Addendum #2

Project: 2024 – Fishers Elementary School Addition & Renovations

ADDENDUM NO: 2

PROJECT: 2024 – Fishers Elementary School Addition and Renovations

SECOND FLOOR EQUIPMENT PLAN - UNIT B

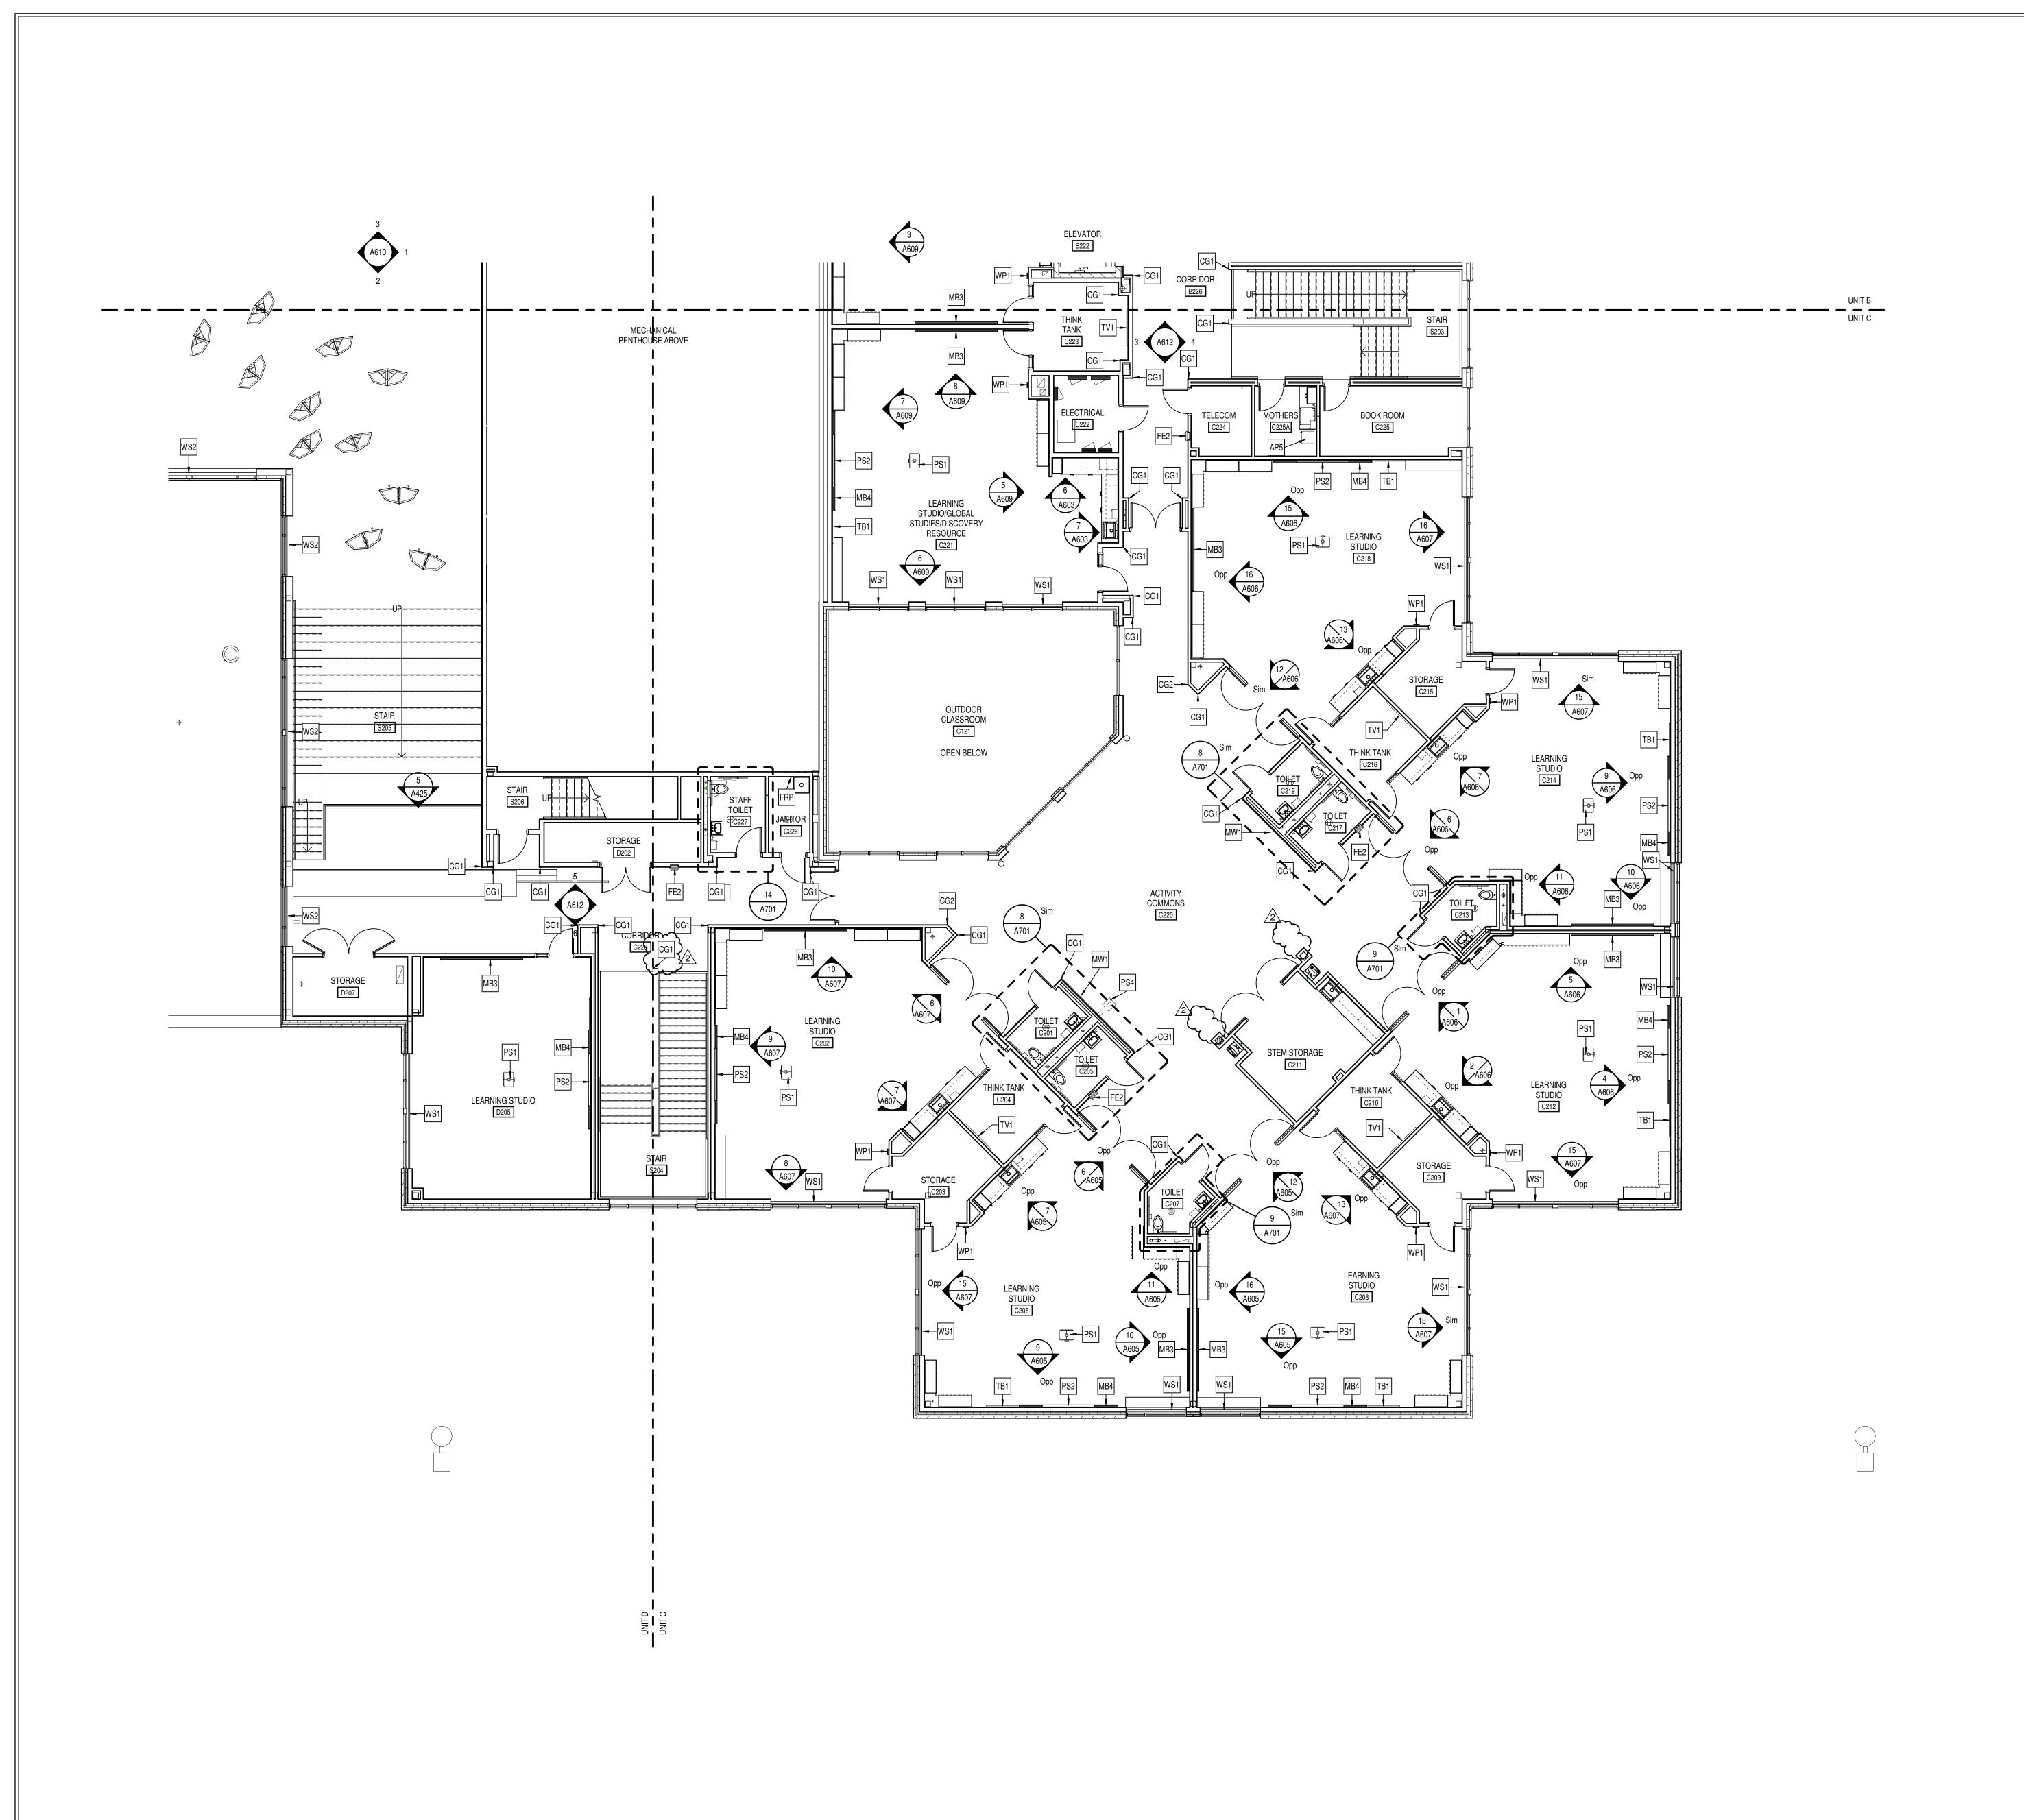
- A. Removed corner guard from ACTIVITY COMMONS A220
- B. Added corner guard to CORRIDOR A230
- 4.38 <u>A902B SECOND FLOOR EQUIPMENT PLAN UNIT B</u>
  - A. Removed corner guard from ACTIVITY COMMONS B220
  - B. Added corner guard to CORRIDOR B226
- 4.39 <u>A902C SECOND FLOOR EQUIPMENT PLAN UNIT C</u>
  - A. Removed corner guard from ACTIVITY COMMONS C220
  - B. Added corner guard to CORRIDOR C228

AD201

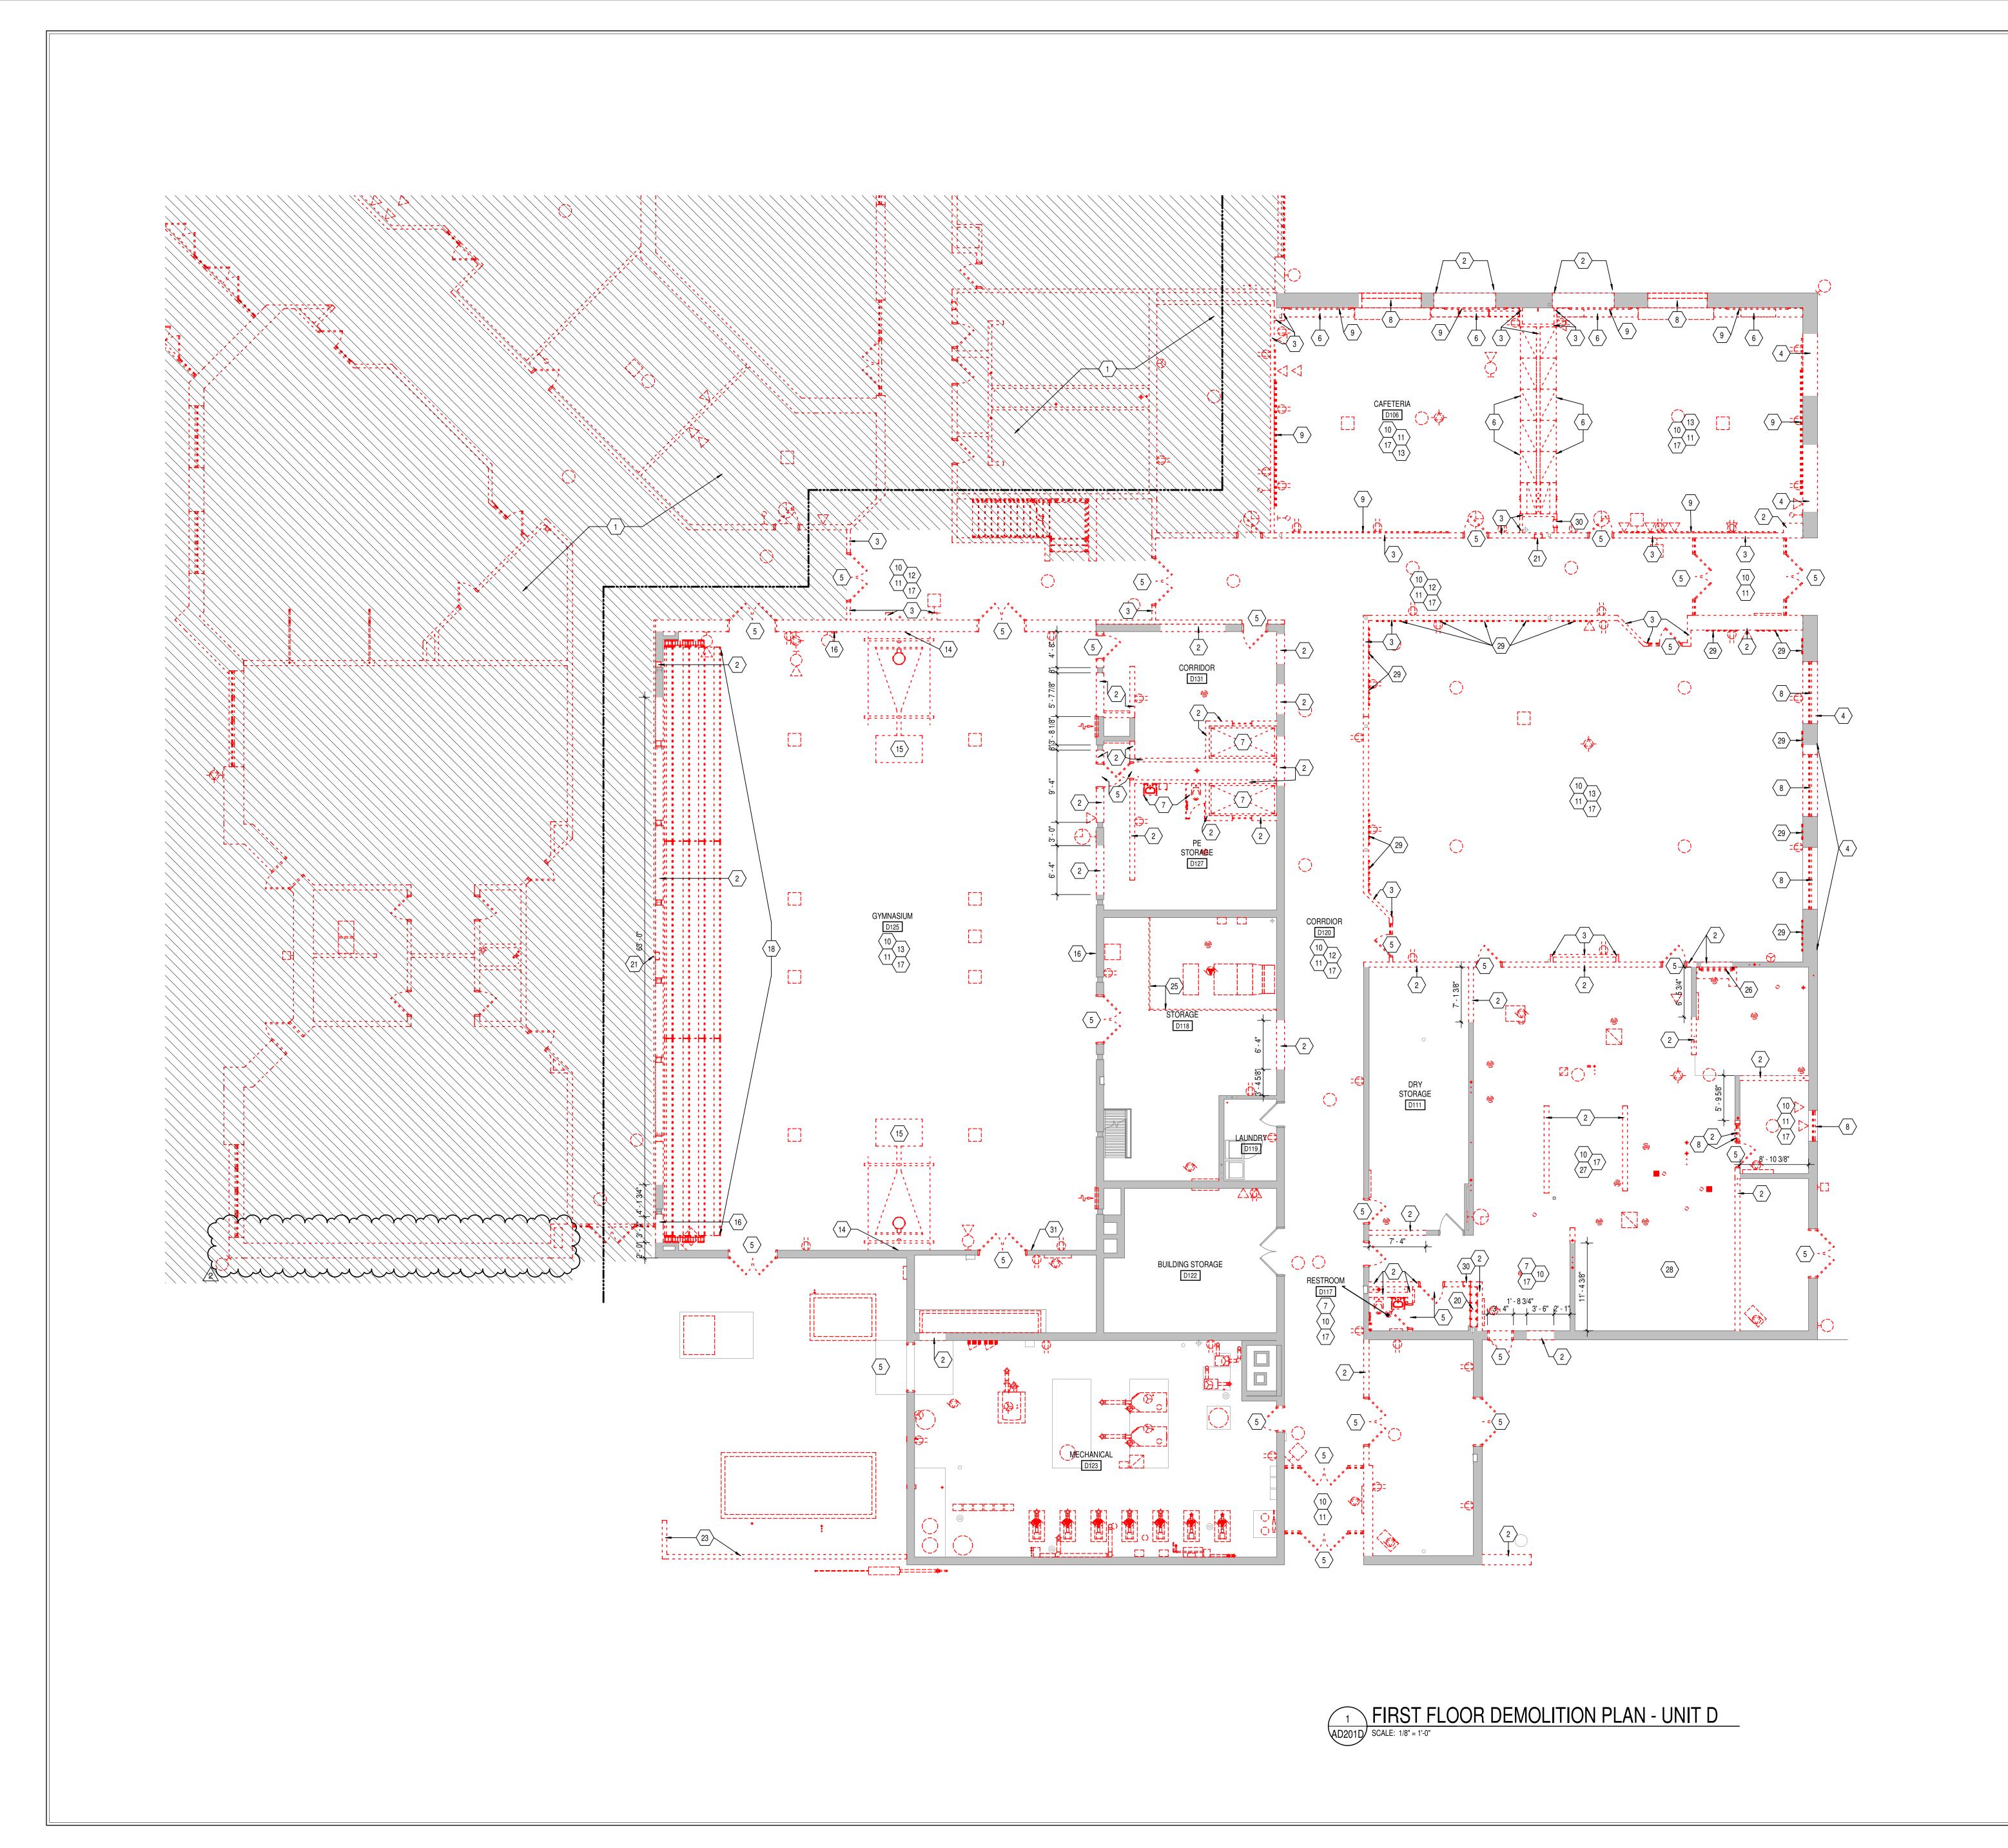
- 4.1 AD201 OVERALL FIRST LEVEL DEMOLITION PLAN
  - A. Revised to include half height exterior wall and canopy columns for demolition
- 4.2 <u>AD201D FIRST FLOOR DEMOLITION PLAN UNIT D</u>
  - A. Revised to include demo'd exterior wall adjacent to Gymnasium
- 4.3 <u>AD201E FIRST FLOOR DEMOLITON PLAN UNIT E</u>

AD202E

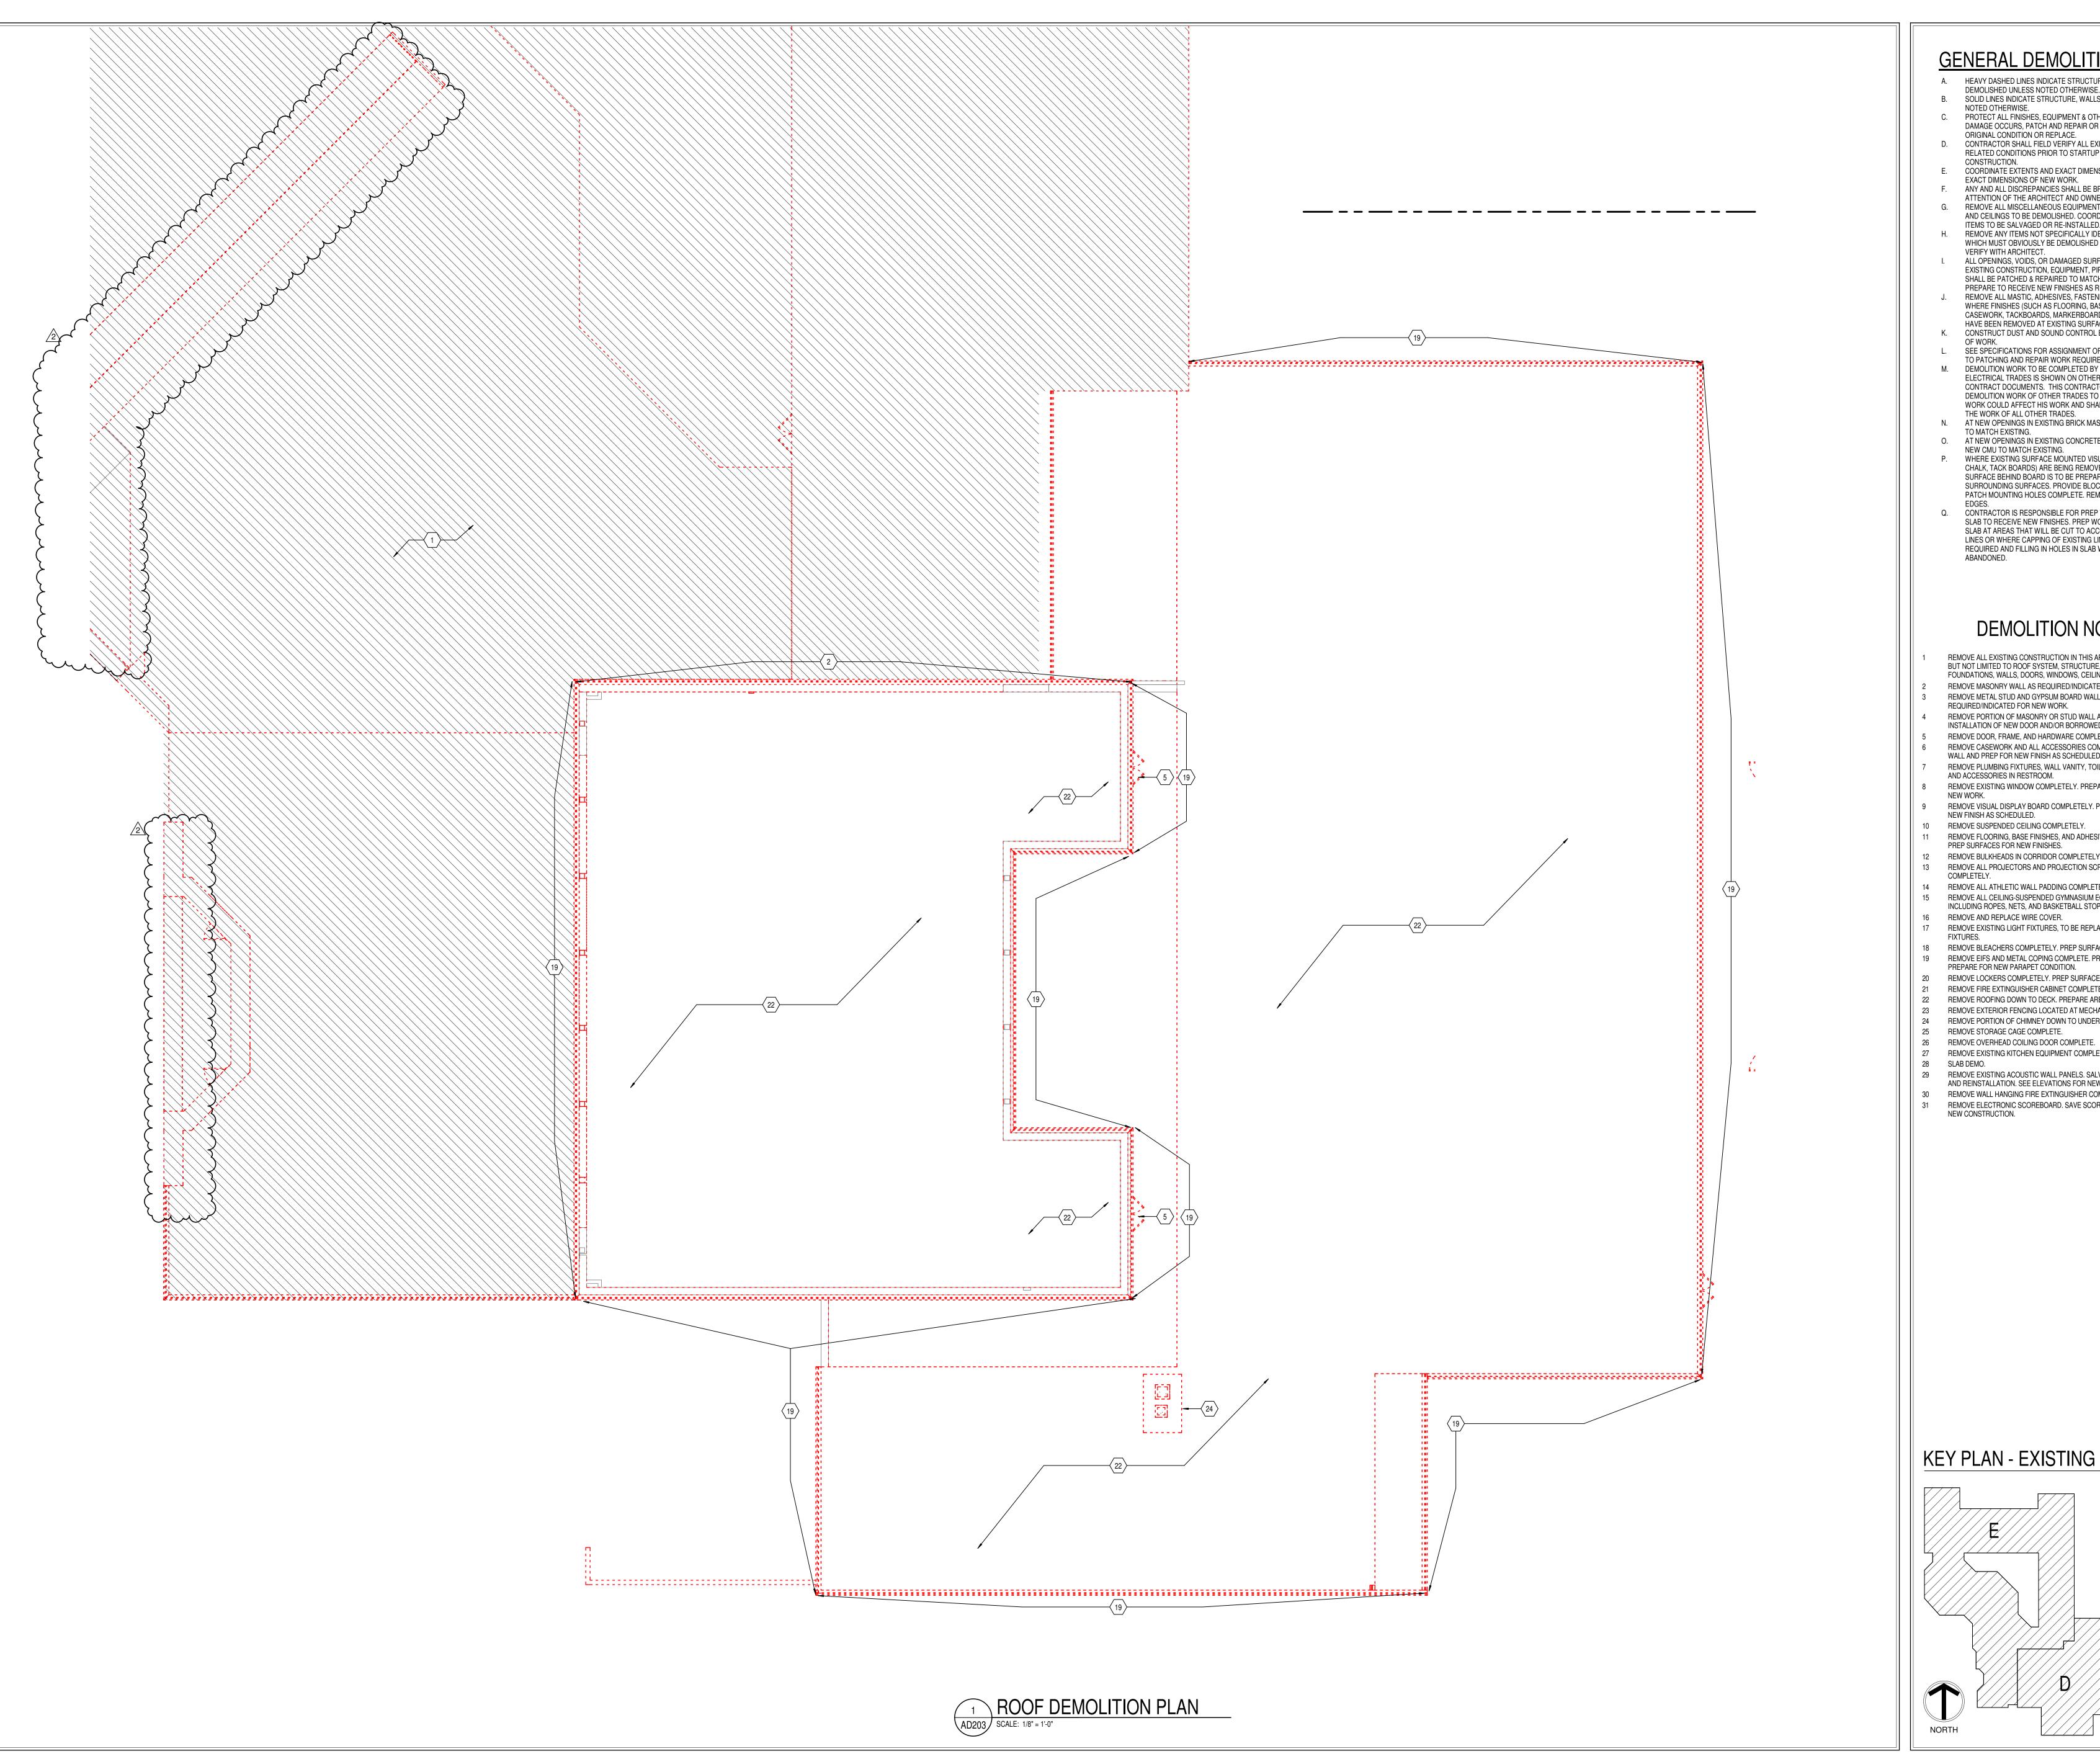
- A. Revised to include canopy and skylight for demolition
- 4.5 <u>AD202E SECOND FLOOR DEMOLITION PLAN UNIT D</u>
  - A. Revised to include canopy and skylight for demolition
